LUFTVÄRDIGHETSDIREKTIV

TITEL: Revision av AFM, kontroll och modifiering av höjdrodertrim

LFS: 1987:9

Beechcraft SB No 2028 Rev III

Pushrod Marking (Temporary)
Figure 1

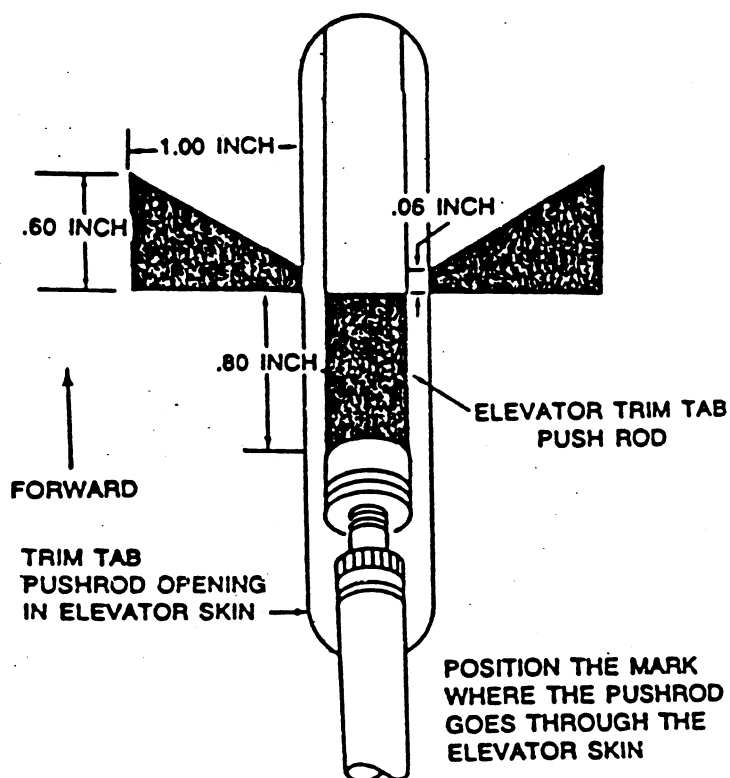
1. Elevator Trim Tab
 - a. VERIFY "O" (NEUTRAL) POSITION
2. On Model 65-A90, B90, C90, C90A and E90 airplanes, the elevator trim tab "O" (neutral) position is determined by observing that the alignment marks on the elevator trim tab pushrods align with the alignment marks on the elevator (See Figure 1 or 2 below), when the elevator is resting against the downstops.
